Application for Amendment to Facility Operating License Credit for Soluble Boron in Spent Fuel Pool Rochester Gas and Electric Corporation R.R. Ginna Nuclear Power Plant Docket No. 50-244

Subject: Application for Amendment to Facility Operating License
Credit for Soluble Boron in Spent Fuel Pool
Rochester Gas and Electric Corporation
R.E. Ginna Nuclear Power Plant
Docket No. 50-244

The enclosed License Amendment Request (LAR) proposes to revise the Ginna Station Improved Technical Specifications (ITS) associated with the Spent Fuel Pool (SFP) Storage (LCO 3.7.13) and Design Features Fuel Storage (4.3).

Figure B 3.7.13-1
Spent Fuel Pool

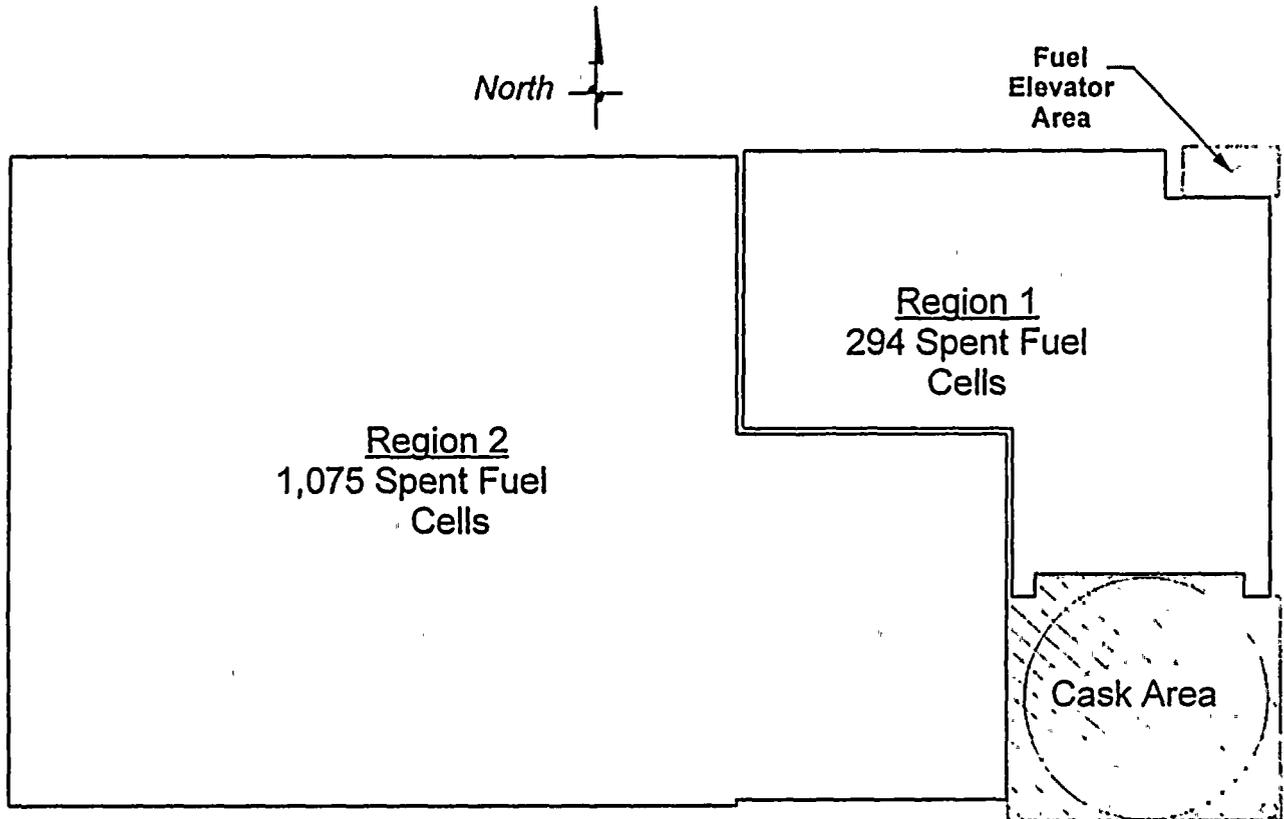
The spent fuel pool (SFP) is divided into two separate and distinct regions (see Figure B 3.7.13-1) which, for the purpose of criticality considerations, are considered as separate pools (Ref. 1). Region 1, with 294 storage positions, is designed to accommodate new or spent fuel utilizing a checkerboard arrangement. All fuel assemblies stored in Region 1 must have a k-infinity that is ≤ 1.458 . The existing design uses Integral Fuel Burnable Absorbers (IFBAs) as the poison for fuel assemblies with enrichments > 4.05 wt% to help achieve this k-infinity limit. IFBAs consist of neutron absorbing material which provides equivalencing reactivity holddown (i.e., neutron poison) that allows storage of higher enrichment fuel. The neutron absorbing material is a non-removable or integral part of the fuel assembly once it is applied. The infinite multiplication factor, K-infinity, is a reference criticality point of each fuel assembly that if maintained ≤ 1.458 , will result in a $k_{off} \leq 0.95$ for Region 1. The K-infinity limit is derived for constant conditions of normal reactor core configuration (i.e., typical geometry of fuel assemblies in vertical position arranged in an infinite array) at cold conditions (i.e., 68°F and 14.7 psia). Fuel assemblies with minimum burnups above the curve in Figure 3.7.13-1 (area A) may be stored at any location within Region 1. Fuel assemblies with minimum burnups below the curve in Figure 3.7.13-1 (area B) may be stored in cells with lead-in funnels only.
